Final Environmental Assessment For 'Aliomanu Road Repair

**Department of Public Works
County of Kaua'i**

September 2009

GENERAL SITE PLAN

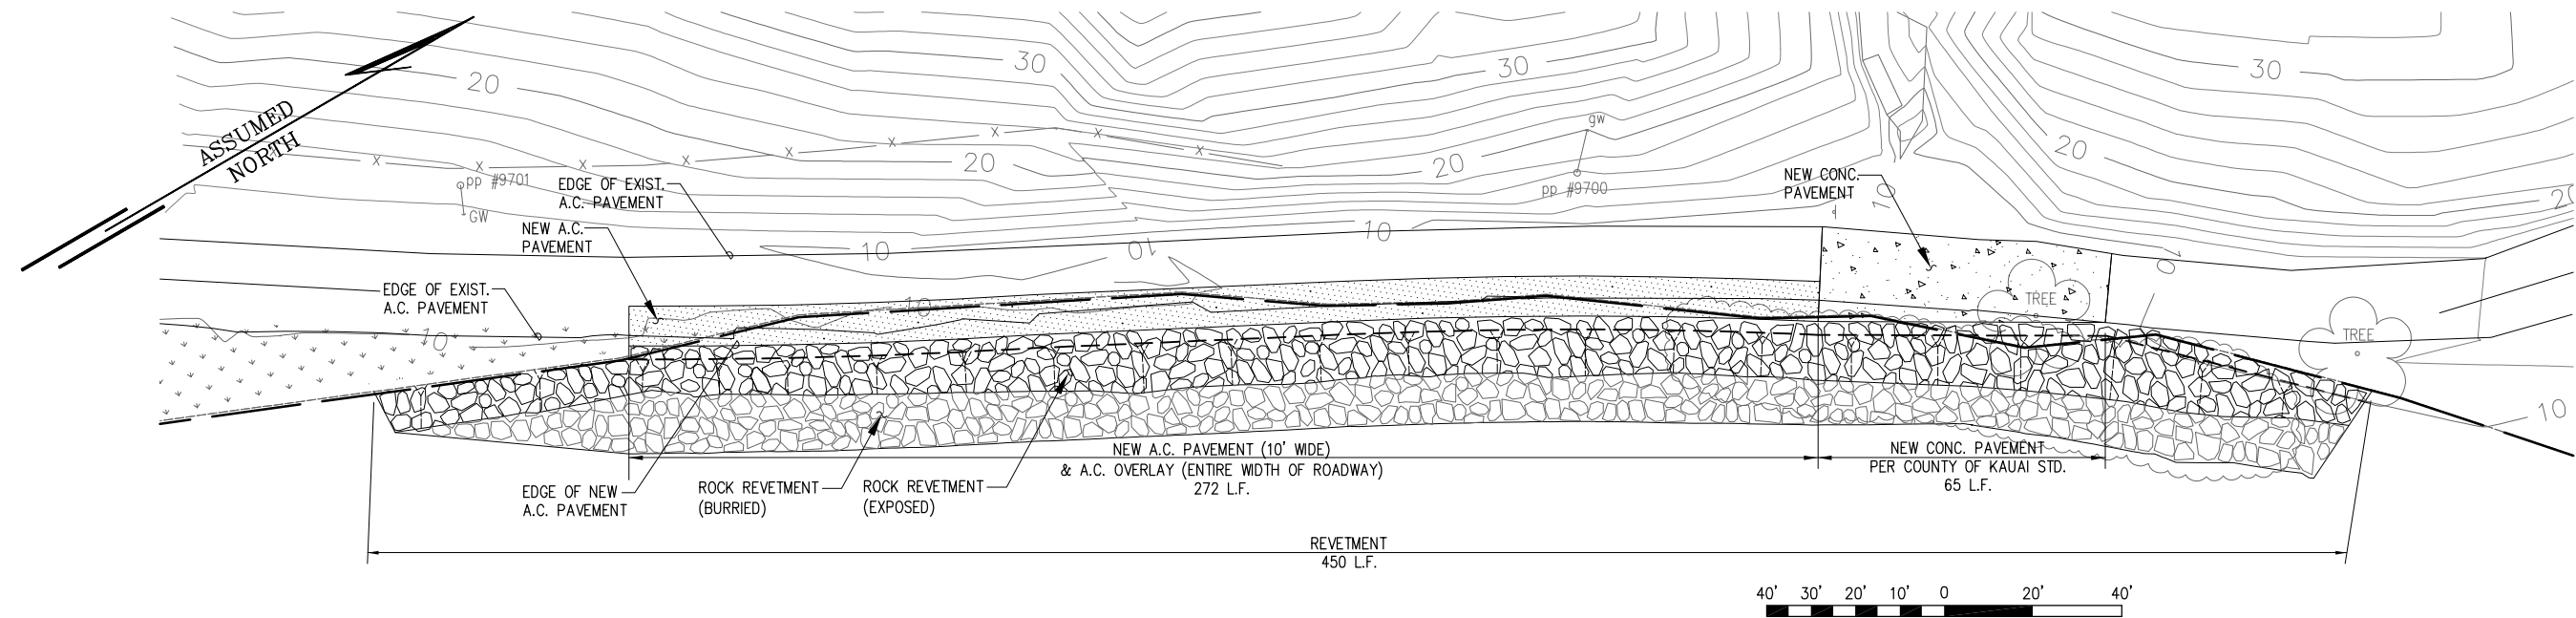
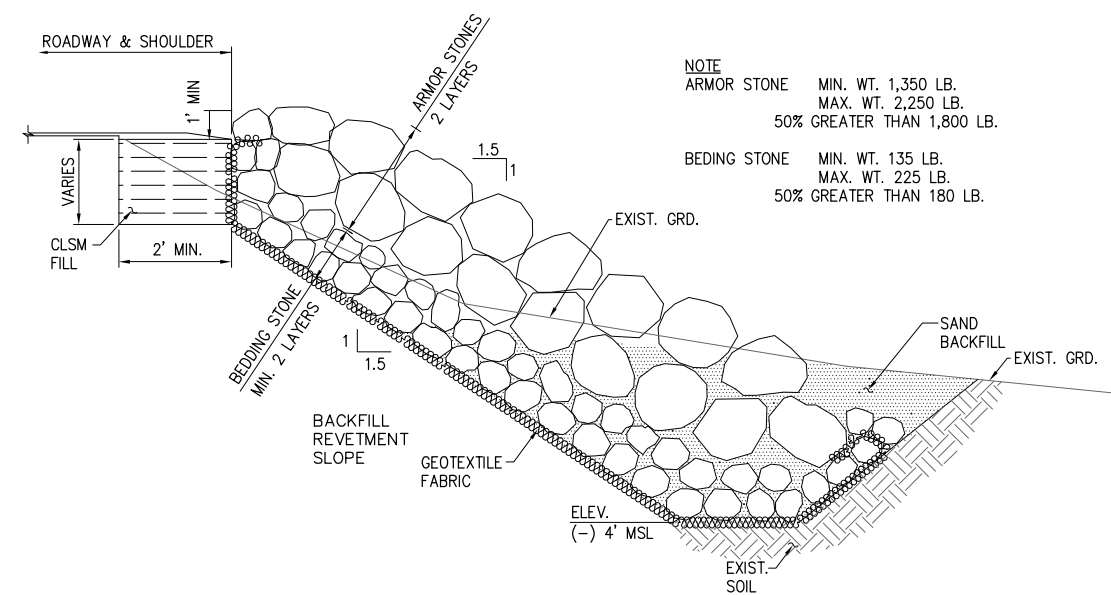
1. We recommend comments be solicited from the County's Flood Plain Manager.
2. Figure 3-1 Plan and Profile of Road Repair and Rock Revetment: The typical roadway section shows a 2 feet minimum shoulder width. The shoulder width is narrow and does not accommodate pedestrian traffic and presents traffic safety problems. We are also concerned with the roadway drainage. We believe the 2 foot shoulder width will serve as a bioretention area to accommodate the roadway drainage. We believe some of the storm flows from the roadway will percolate through the 2 foot strip and will be trapped between the geotextile fabric separating the rock revetment and filled section of the roadway repair and will further erode or undermine the roadway prism.

3. It appears the project area includes submerged lands seaward of the upper reach of the wash of the waves. The DEA should include a map depicting the high tide line and shoreline for reference in relation to the proposed actions. Please include a copy of a shoreline survey and include the shoreline on Figure 3.1 in the plan view and cross-section.

- 11. *Figure 3-1.* Please add the total structure length and the shoreline to the figure. Figure 3 of Appendix C Cultural Survey Report indicates a much larger project area.

- 12. *Figure 3-1.* Please provide the estimated structure height and width ranges (currently reads varies) to the figure. It is not clear from this figure how far seaward the proposed activities will extend.

- 13. *Figure 3-1.* Please describe the quantity and type of fill material to be used as backfill behind the revetment.
- 14. *Section 4. Physical, Biological and Cultural Environment.* Please add a coastal resource assessment. This section should include:

7. *Section 2.1 Project Description* – We will add the basic dimensions and a graphical scale into the plan and profile drawing (Figure 3-1).
8. *Section 3.2 Proposed Project Alternative* – Oceanit received a preliminary geotechnical report; however, the proposed revetment was not being considered at that time. The findings on soil type are valid, but the discussion on using the concrete retaining wall alternative is no longer applicable. We will add the preliminary report as an appendix to the FEA.

11. *Figure 3.1* – We will add a dimension to the figure for the 500-foot revetment length.
12. *Figure 3.1* – We added a graphical scale to the figure's plan view so that dimensions can be measured.

13. *Figure 3.1* - Fill material to build the revetment slope and road bed includes sand, rock, existing soil, and flowable fill (thin concrete). Total fill volume is approximately 2800 cubic yards.
